Errata Sheet

Product Family:	Terminator I/O Profibus DP Base Controller Manual	Date:	August, 2020
Manual Number	T1H-PBC-M		
Revision and Date	1st Ed., Rev. A; April, 2004

NOTE: T1H-PBC module and User Manual have been retired as of 08/2020. No replacement is available.

Pages 1-7. Introduction; T1H–Profibus Base Controller:

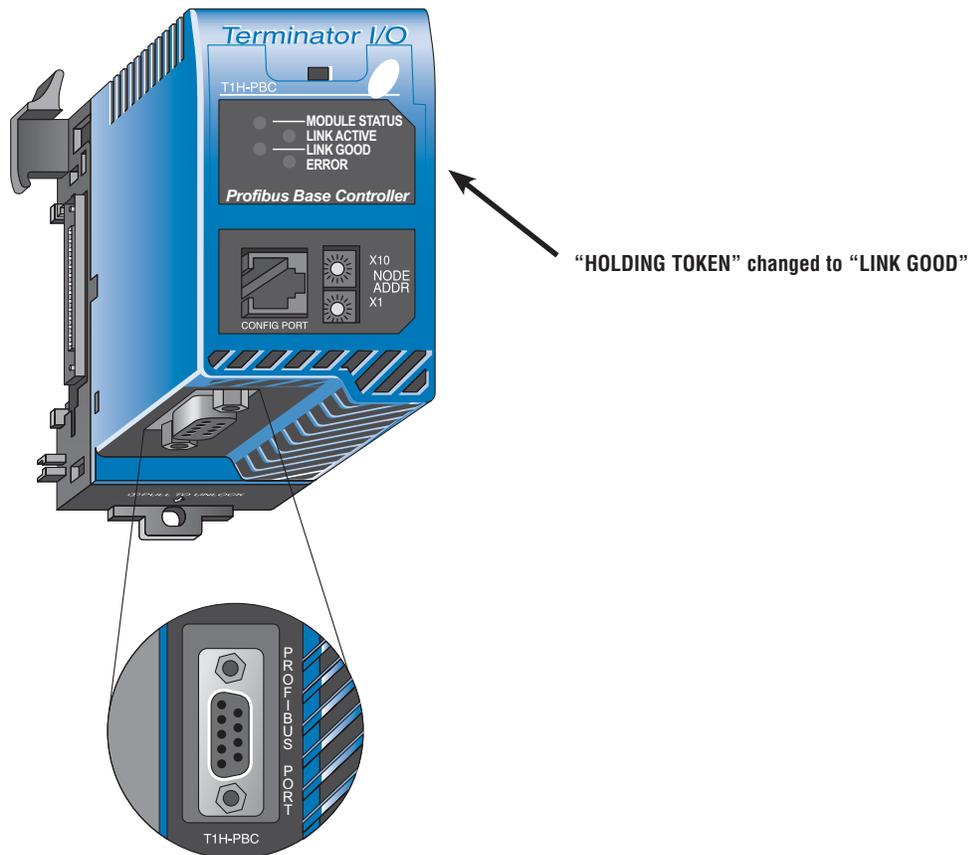
The T1H-PBC module faceplate changed. The status indicator named “HOLDING TOKEN” was changed to “LINK GOOD”. The status indicator function did not change.

Pages 1-6, 2-3, 2-4, and 2-5 all have drawings showing the old faceplate. “HOLDING TOKEN” is also referred to on pages 2-10 and A-2. Change all references to “HOLDING TOKEN” to “LINK GOOD”.

For example, replace the drawing on page 1-7 with this one:
